## Friends of Oakley Farm Pastures: Alternative Masterplan/Gradients Response

1. In response to the appellant's landscape note of 11 Oct 2021 and their email dated 10 Dec 2021 (regarding submissions as to why the inspector should accept the additional information that the appellant has provided on the alternative masterplan issue), the Friends of Oakley Farm Pasture Slopes, FOFPS, have the following observations (our bold/footnotes):

### **The Alternative Master Plan / Planning Gradients Plan**

Fig. 1 Eastern Road Sections pt1

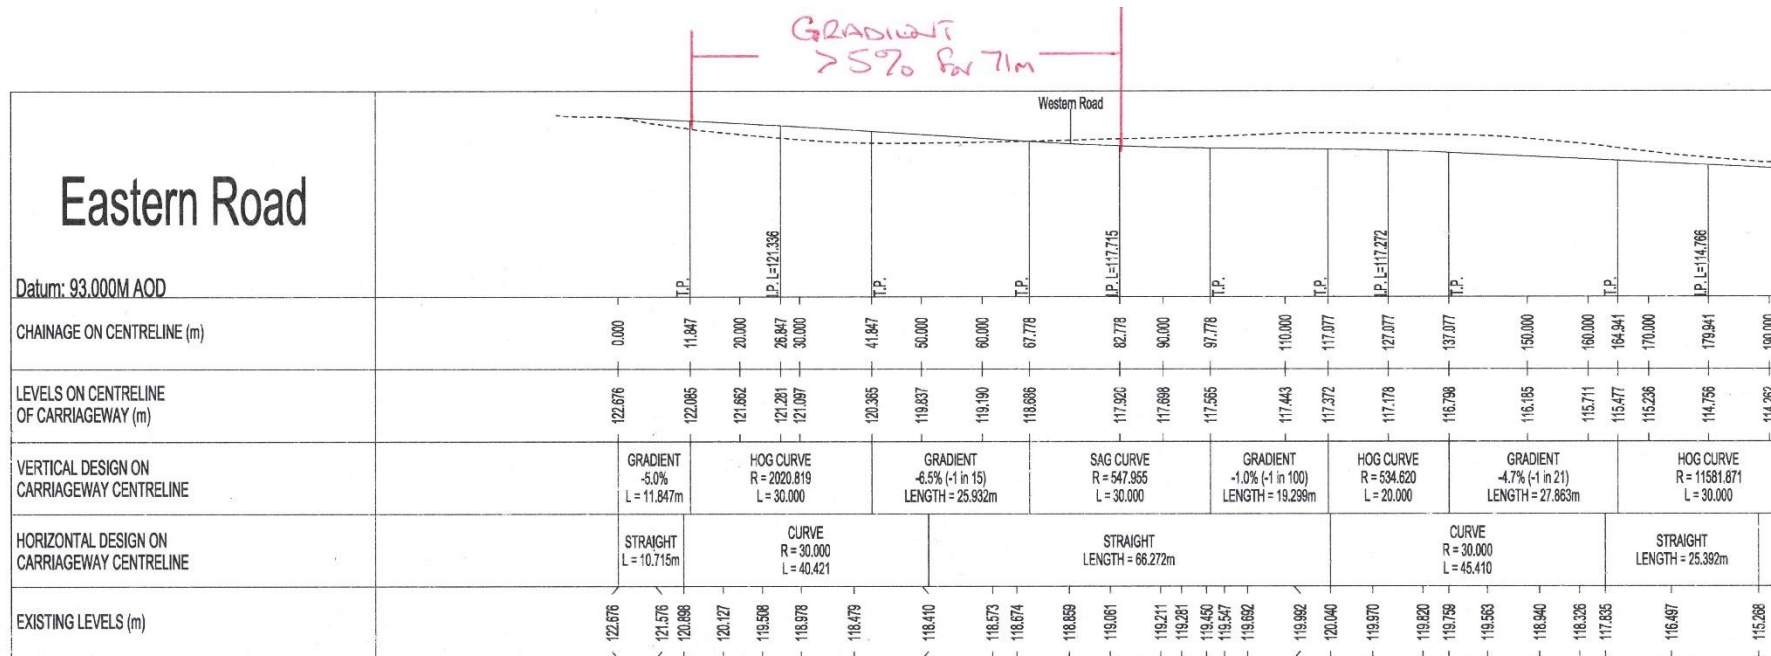
a. From the Road Long Section Plans. When considering the Eastern Road between chainage points c.11m and 83m the average gradient is in excess of 5% for 71m (see Figs. 1 & 4) and between chainage points

Fig. 2 Eastern Road Sections pt2

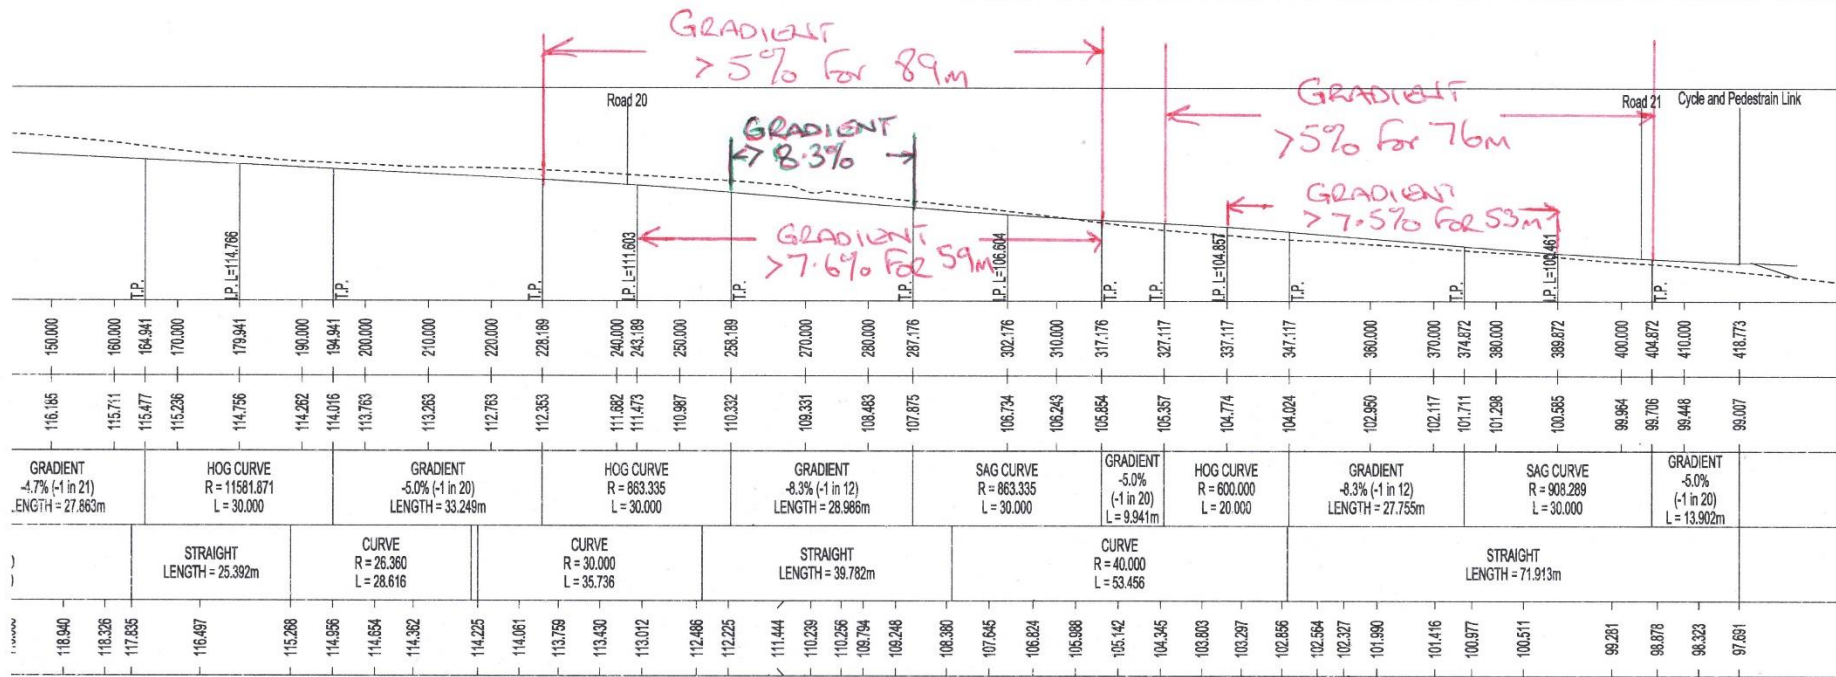
c. 228m and 405m there are significantly steeper average gradients in excess of guidance. The average gradient over this 162m long section is 1:13.7 (7.3%) including just one short 10m section at the normal recommended maximum gradient of 5% (see Figs. 2 & 4).

b. The Western Road in total is 305m in length with an average gradient of 7.2% or 1:13.9. Within this length there are only 3 sections, 46m total, of "slack" gradient at the recommended maximum of 5%. This road has steep average gradients over extended lengths which exceed guidance. One section runs for 58m at 8.6% (1 in 11.6) (see Figs. 2 & 5).
